DATE: June 24, 2013

SUBJECT: Addendum No. 4
Project # 66106 Green Valley Road/Silver Springs Parkway Intersection
Project # 66107 Silver Springs Parkway Realignment Onsite Phase-2
Project # 66114 Green Valley Road/Deer Valley Road Turn Lanes
Joint Trench Composite Drawing for Silver Springs Unit #1
PW 09-30470, CIP No. 76107 & 76114

JOINT TRENCH COMPOSITE DRAWING
SILVER SPRINGS UNIT #1

SILVER SPRINGS
GREEN VALLEY RD & SILVER SPRINGS PKWY
INSTALL CONDUIT CROSSINGS

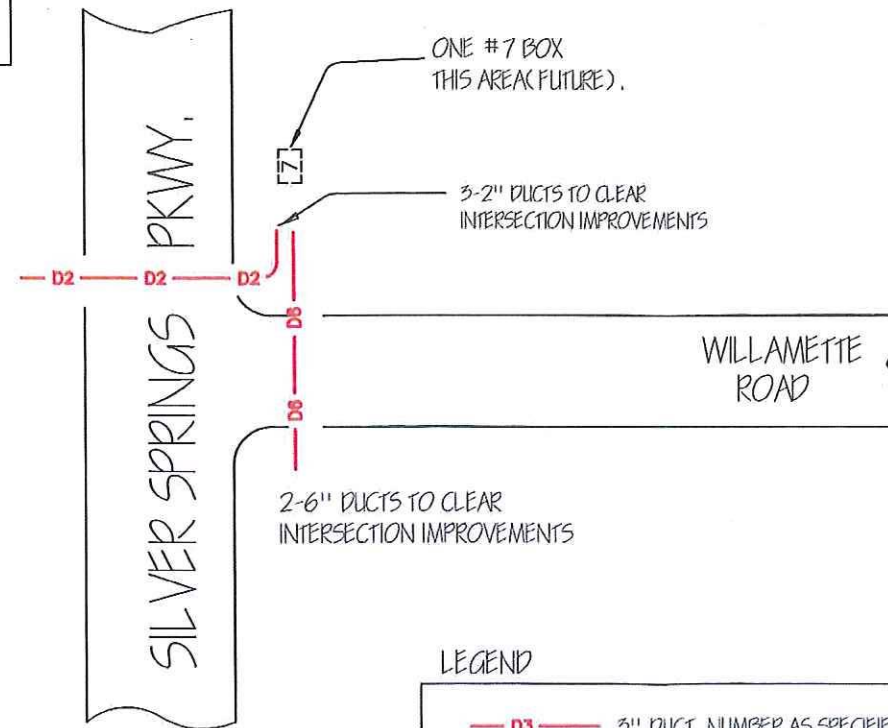
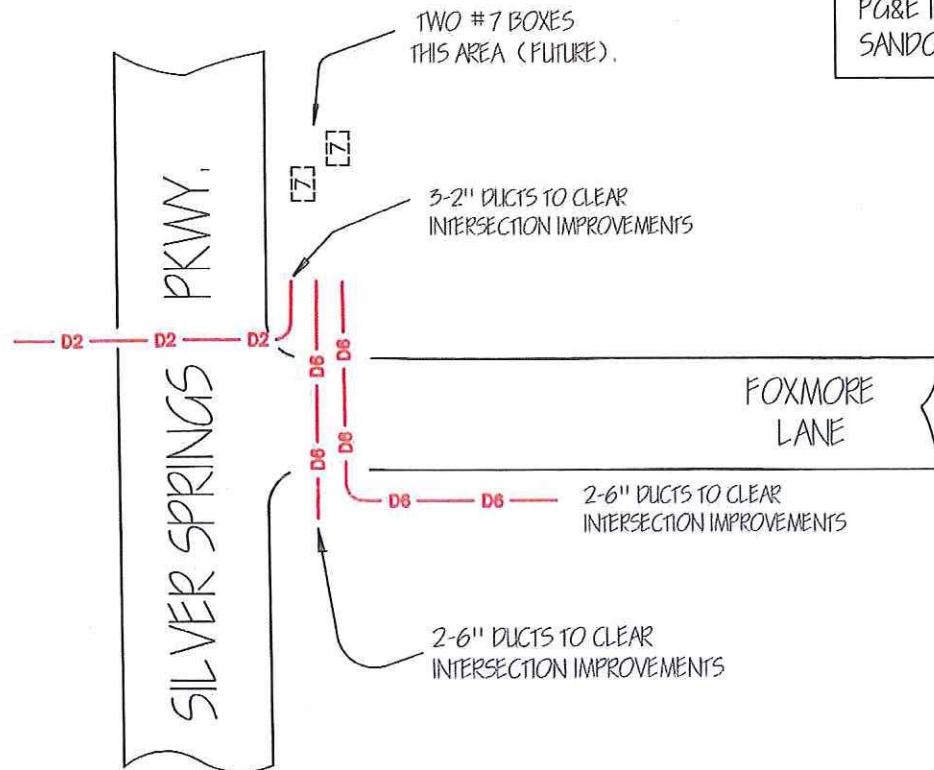
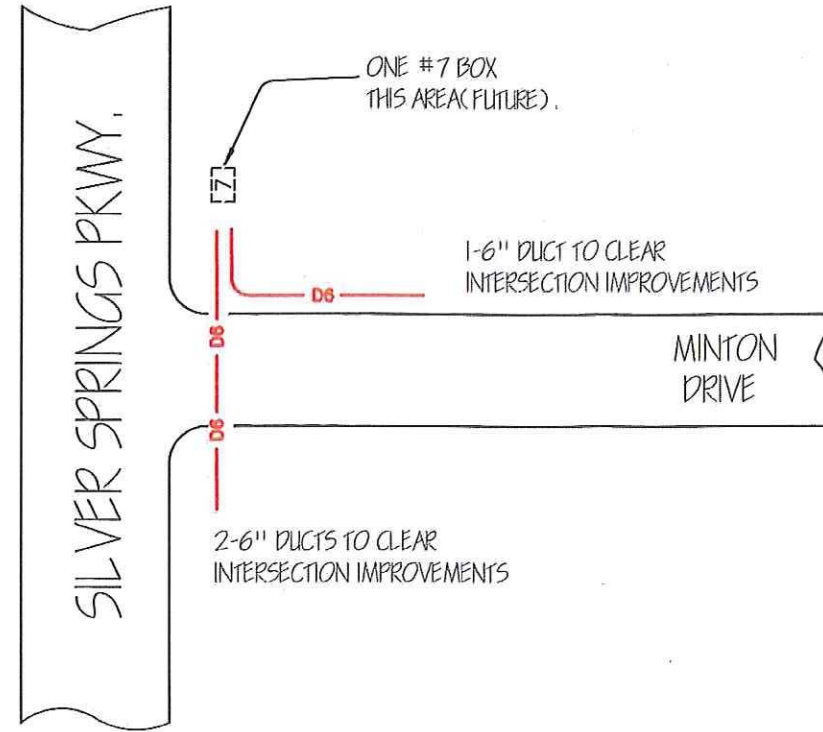
ITEM NO.	LOCATION, PAGE, OR DRAWING NO.	DESCRIPTION OF CHANGE
4.01	Joint Trench Composite Drawing Silver Springs Unit #1 Plans (Plans), SP-243, C-10, P-5	<p>Refer to Response to Bidders' Inquiries No. 5 Item 5.03 and Response to Bidders' Inquiries No. 6 Items 6.06 and 6.08:</p> <ul style="list-style-type: none"> A. The bid quantity for Bid item # 106 "Joint Trench" has been revised. See item 4.06 below. B. Replace sheets 5 through 10 of the Plans with sheets 5 through 10 attached to this Addendum. C. Replace Notes 1, 5, 6, 7, 10 and 17 under DRY UTILITY CONSTRUCTION on sheet 2 of the Plans with the following: <p>"The scope of work for Bid item 106 includes installing conduit for future telephone, CATV, and electrical utilities and gas lines only at the road crossings. The work on sheets 2 through 6 (revised as applicable) includes only the clouded areas. It also includes installing Type G ETS stations and 5lb zinc anodes as shown on revised sheets 7, 8, and 9. Bidders are instructed to refer to sheets 2 through 6 (revised as applicable) for the telephone and CATV conduit sizes, lengths, and locations; revised sheets 7 through 9 for the gas line sizes, lengths and locations and for the number and locations of the Type G ETS stations and 5lb zinc anodes; and sheet 2 for the electrical conduit lengths and revised sheet 10 for the number, size,</p>

<p>and location of the electrical conduit.”</p> <p>D. No installations are required at locations 57 &58.</p> <p>E. Section10-1.60 “Joint Trench” of the special provisions:</p> <ol style="list-style-type: none"> a. Delete the 4th paragraph. b. Replace the last paragraph of this section with: <p>“The contract price paid per linear foot for joint trench shall include full compensation for furnishing all labor, materials, tools, equipment, and incidentals, including preconstruction meeting, all coordination of inspections with utility companies and for doing all the work involved in placing the joint trench, including excavation, disposal of excavated material, placement of ducts and pipes, pull ropes, dewatering, backfilling, and compacting the trench, installation of Type G ETS stations and 5lb zinc anodes, and any other items shown within the clouded areas of sheets 2 through 6 and shown on sheets 7 through 10 as revised by Addendum No. 4”.</p>

Revised on 6/18/13
for Addendum No. 4
